# Product Change Notification

## 106423 - 01

**Change Notification #:** 106423 - 01  
**Change Title:** S5000PSL, PCN 106423-01, Product Design, Class 1, System Software Update, Thermal Sensor Reliability, Reason for Revision: Update MM#  
**Date of Publication:** June 27, 2006

Wide View:

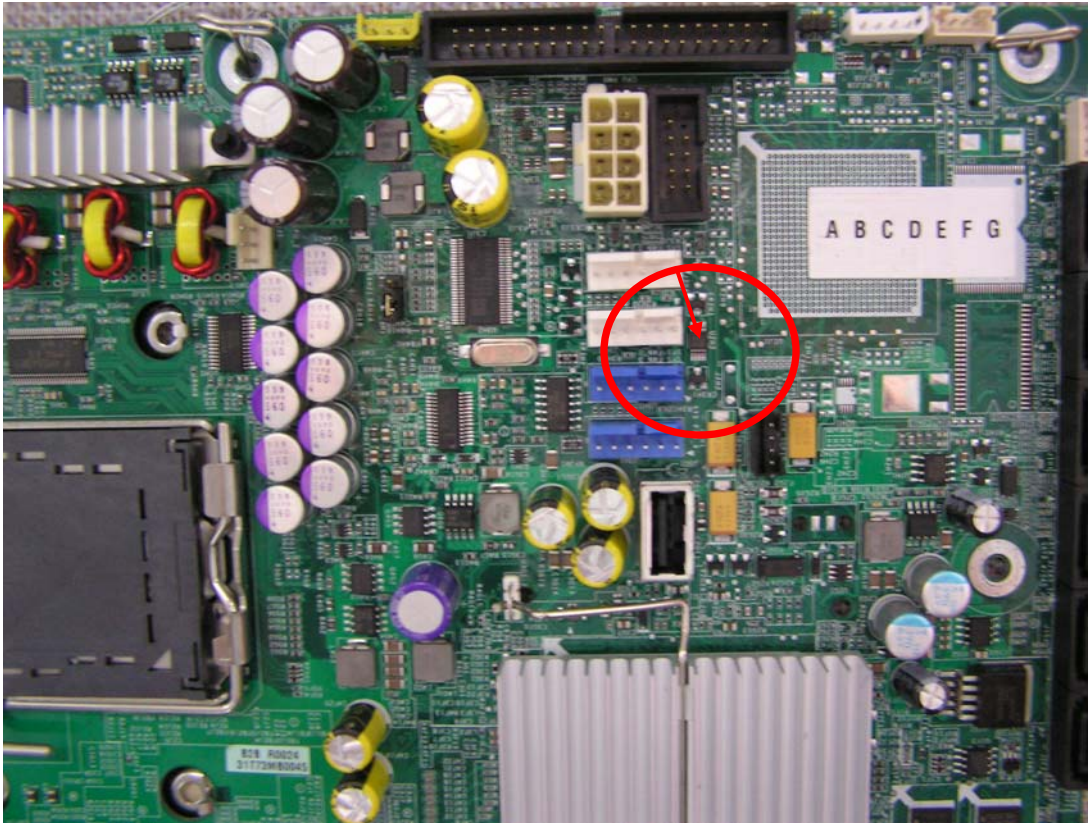
Change 2) A wire is being added to the baseboard to increase the reliability of the baseboard thermal sensor (BB TEMP Sensor #30). The wire will ground pin #4 and pin #5 of the thermal sensor component at the location U2H2.
